PLANNING COMMISSION STAFF REPORT

Meeting: June 14, 2022

Consider an appeal of the Community Development Director's approval of a Two-Story Permit to consider the construction of a new 3,233-square-foot, two-story single-family residence, and an attached 797-square-foot Accessory Dwelling Unit (ADU) (Application No.: R-2021-023; Applicant: Kyle Chan.; Property Owners: Dung N. (David) Do & Wen Hsiu (Cristina) Hung; Appellant: Sanjiv and Deepika Kapil; Location: 6522 Clifford Dr; APN # 369-24-037)

Figure 2. Planting Plan.

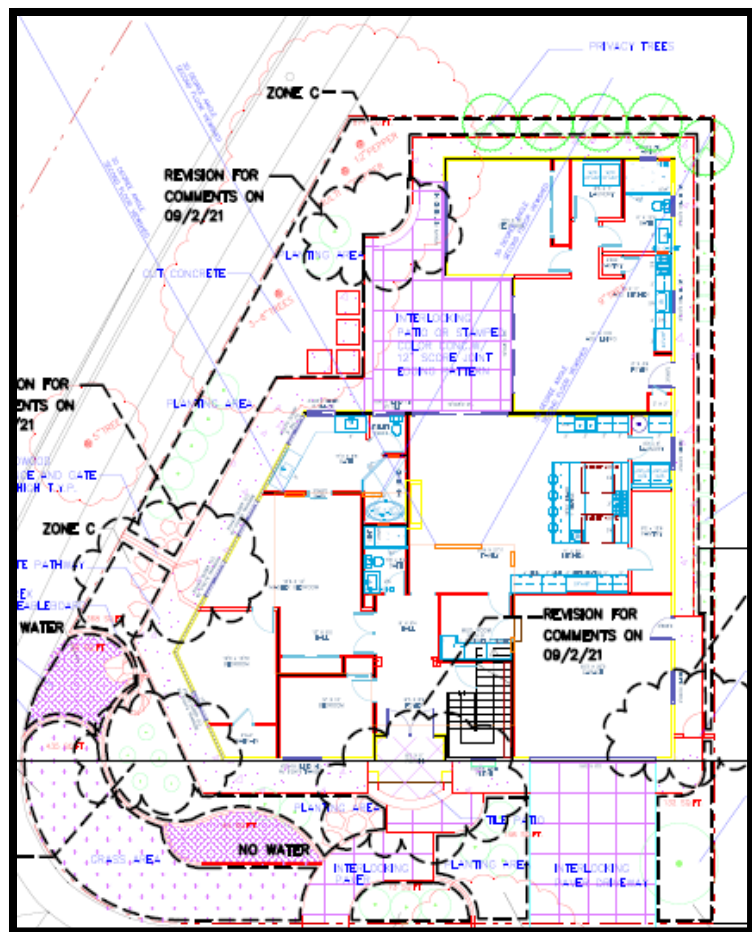
“Second Story three windows shown A3.2 (south) elevation gives direct view of two neighbors backyards and they also violate floor to lower edge height guidelines of minimum 5 ft.”

Per the R-1 Ordinance, a reasonable level of privacy is afforded to neighbors, rather than complete privacy and as a result, the objective of privacy protection plantings is to provide substantial, not complete, screening within three years of planting to mitigate second-story window privacy impacts. The project complies with the privacy screening requirements of the R-1 Ordinance by providing privacy screening plantings for the second-story windows with a sill height below five feet along the rear (southern) property line (Figure 2).

The applicant has proposed to plant five *Laurus nobilis*, one of the City's approved privacy planting species, along the rear property line spaced at the appropriate distance to provide screening to the neighbor along the rear (southern) property line and a very small portion of the appellant's rear yard (see

green outlines in Figure 2). The City's approved list of privacy plantings requires *Laurus nobilis* to be at least 15-gallon container size and have a minimum planting height of six feet. Additionally, while views into front yards are not required to be mitigated per the Cupertino Municipal Code, the applicant is proposing to retain three existing pepper trees, located along the rear (southern) property line and along the street side (eastern) property line to provide additional screening for the adjacent neighbor on the south. It should be noted that this neighbor has not raised concerns about the applicant's choice of privacy planting.
